- 8. Rosewood Subdivision Farmgirl Addition; KPB File 2025-093
Seabright Survey & Design / Rainwater, Hendon
Location: Kilak Court off Glacier View Road N.
Fritz Creek Area**

**ITEM #8 - PRELIMINARY PLAT
ROSEWOOD SUBDIVISION FARMGIRL ADDN**

KPB File No.	2025-093
Plat Committee Meeting:	July 14, 2025
Applicant / Owner:	Shelley Rainwater and Joseph Hendon of Homer, Alaska
Surveyor:	Katie Kirsis / Seabright Survey + Design
General Location:	Fritz Creek

STAFF REPORT

ROSEWOOD SUBDIVISION FARMGIRL ADDN.

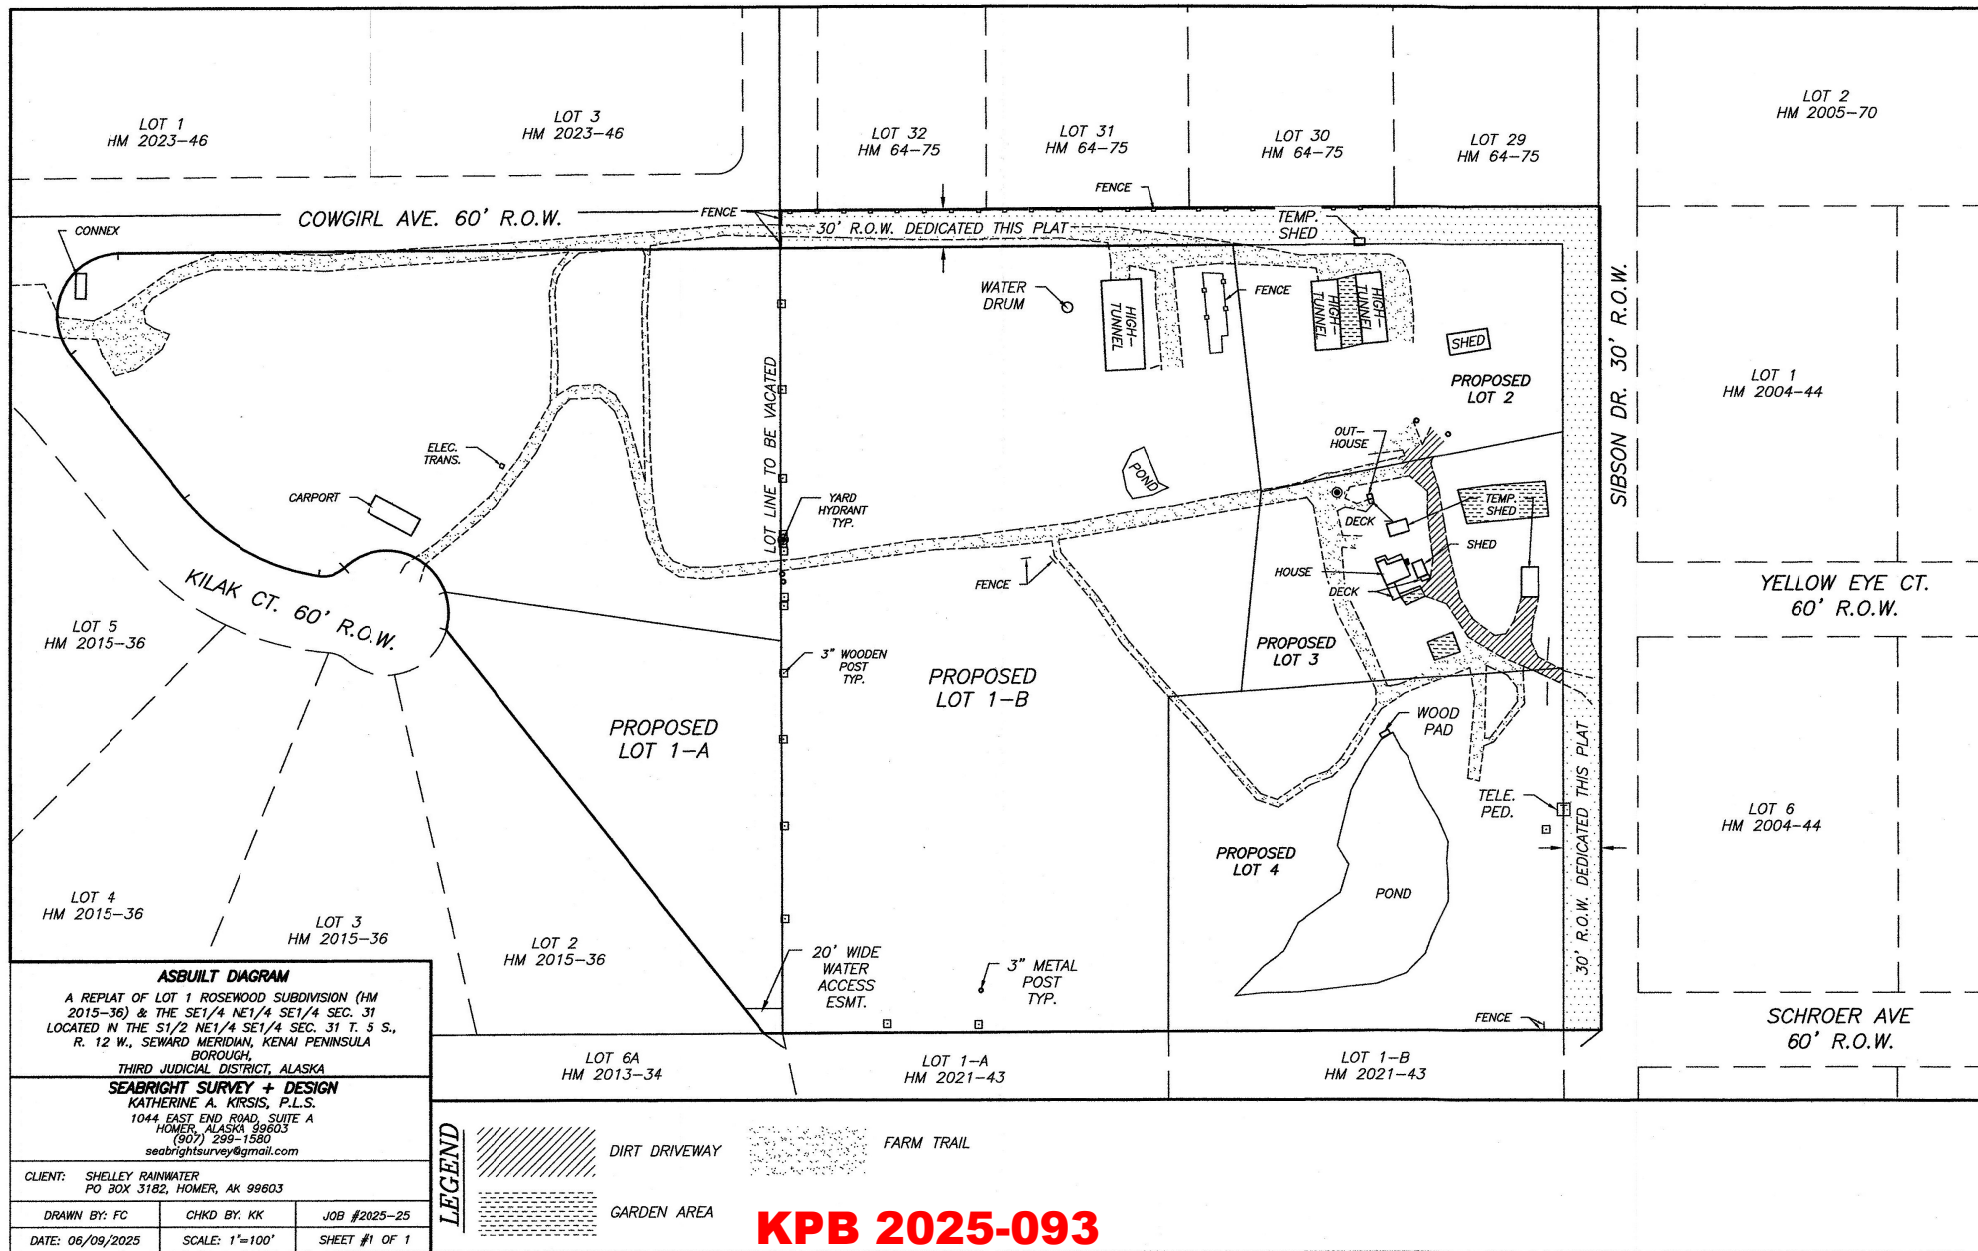
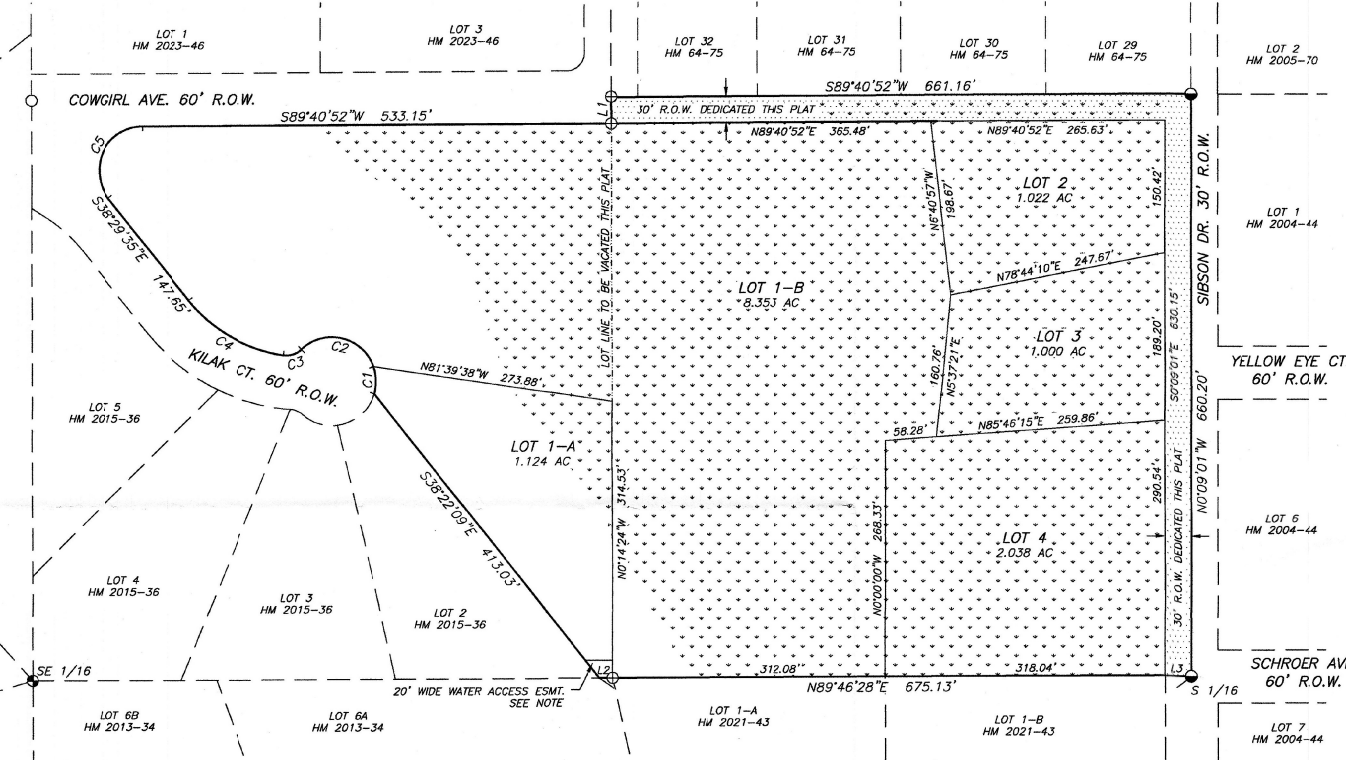
The plat proposes to dedicate 30 feet to Cowgirl Avenue as it continues east. Staff believes this dedication is unnecessary with the dedication of Mesa Avenue just to the north. **Staff recommends** a dedication of 30' by 30 be dedicated to complete the turn north from Cowgirl Ave to Woape St.

KPB data indicates there is a 66-foot section line easement located to the east within the Sibson Drive dedication. 33-feet is located on either side of the section line. **Staff recommends** the surveyor verify and depict and label the section line easements on the final plat.

According to the as-built provided by the surveyor and confirmed by KPB GIS Imagery and KPB Assessing records, multiple improvements are located to the east of the plat. A driveway and farm trail appears to cross proposed lots 1-B and 2 through 4. **Staff recommends** If the driveway and farm trail are to be continued to be used for all lots and no new driveways are to be installed or limited, a driveway agreement / easement be recorded prior to the sale of any of the lots.

According to the KPB GIS contours layer, there are small areas within the subject location with slopes greater than 20%. **Staff recommends** the surveyor provide a label depicting the top and toe of slope on the final plat submittal. or directional with grade

According to the KWF Assessment, wetlands identified as discharge slope affect the majority of the plat. This area has been represented on the preliminary plat submittal. A pond is located in the southeast on proposed Lot 4. **Staff recommends** the surveyor include a depiction and label for the pond and include plat notes relating to the certificate to plat items #10 and #11.

A soils report will be required and an engineer will sign the final plat as the new lots 1-A and 2-4 are less than 200,000 square feet **Staff recommendation:** modify the wastewater disposal note to comply with KPB 20.40 as determined by the soils report.

A right-of-way easement was granted to Homer Electric Association as recorded in Book 19, Page 10, HRD. **Staff recommends** the surveyor modify plat note number 5 to include the correct document number.

A water source easement affects proposed Lot 1-A as recorded in document 2015-003149-0 HRD. This easement is listed as plat note 8 and is depicted on the plat. **Staff recommends** the surveyor include the corresponding plat note in the label depicting the easement and change the line type associated to the easement. Modify plat note number 8 to reflect the correct affected lot.

The plat is proposing on the east portion of the plat a 10' utility easement along the right-of-way as noted at plat note 1. **Staff recommends** the utility easements along the right-of-way be uniform and should be as carried forward from the parent plat at 15'.

- Remove Plat Note Number 7
- Plat Note #6 contains a subdivision that is not within the same section of this subdivision. Please remove plat note number 6 or modify to correct plat number.
- Add the meeting date to the Plat Approval
- Add Joseph Hendon to the Certificate of Ownership and Dedication and add ownership lots to names.
- Add a plat note for items 10 & 11 from the certificate to plat.
- Add to the Plat Approval the date of July 14, 2025

- Include Joseph Hendon as an owner
- Modify "Clients" to "Owners" within the title block
- Section 31 may be removed in the second line of the legal description
- Modify the KPB File Number to 2025-093

- Depict and label the SLE to the east and add CTP item #9
 - Add CTP items #10 & 11 and the affected parcels
 - Plat Note #6 contains a subdivision that is not within the same section of this subdivision. Please remove plat note number 6.

- Modify Plat Note 5 to Book 19 Page 10
- G. The status of adjacent lands within 100 feet of the proposed subdivision boundary or the land status across from any dedicated rights-of-way that adjoin the propose subdivision boundary, including names of subdivisions, lot lines, block numbers, lot numbers, rights-of-way; or an indication that the adjacent land is not subdivided;
Staff recommendation:

- Provide a label for the name and width of Woape Street to the north
 - Provide a label for the parcel to the west, Lot 1, BLK 2, HM 77-17
 - Depict and label the private access easement and Glacier View Road to the west

- Depict and label the pond

ROSEWOOD SUBDIVISION FARMGIRL ADDN.

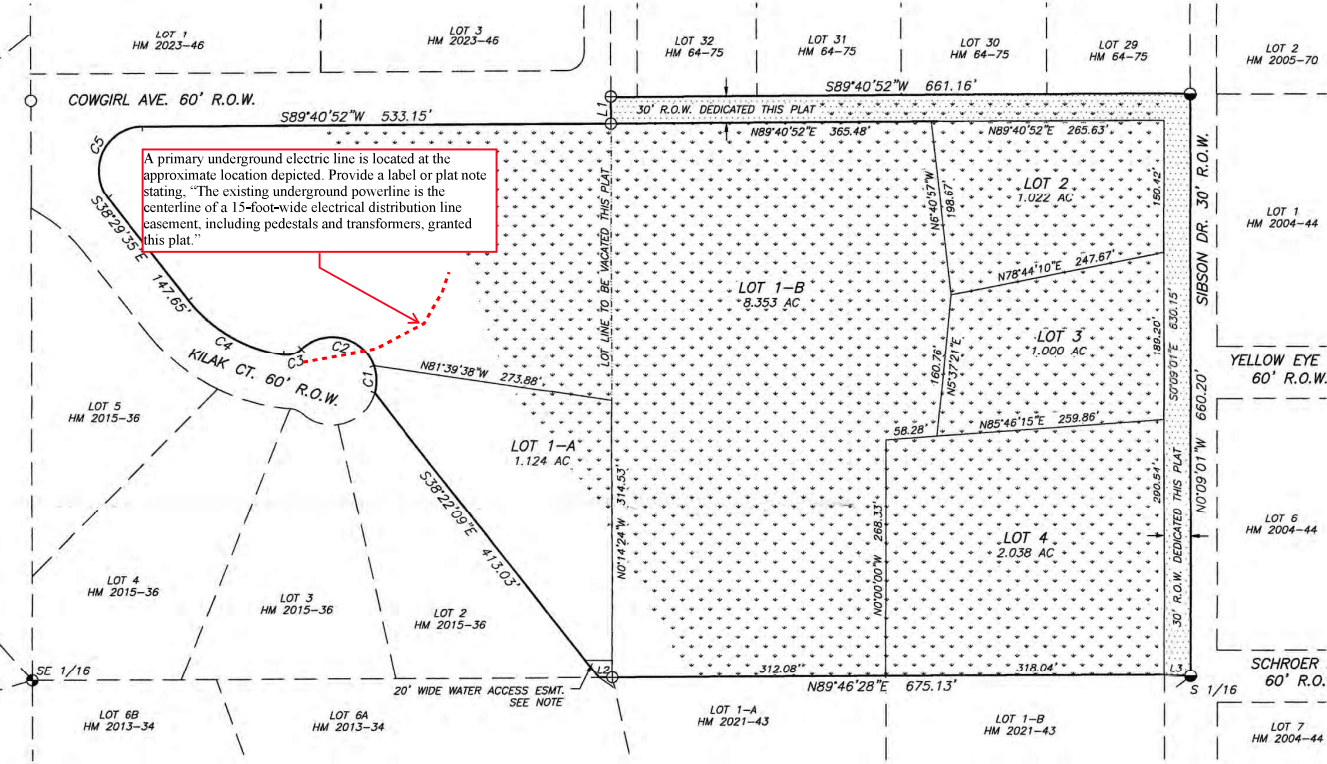
A primary underground electric line is located at the approximate location depicted. Provide a label or plat note stating: "The existing underground powerline is the centerline of a 15-foot-wide electrical distribution line easement, including pedestals and transformers, granted this plat."
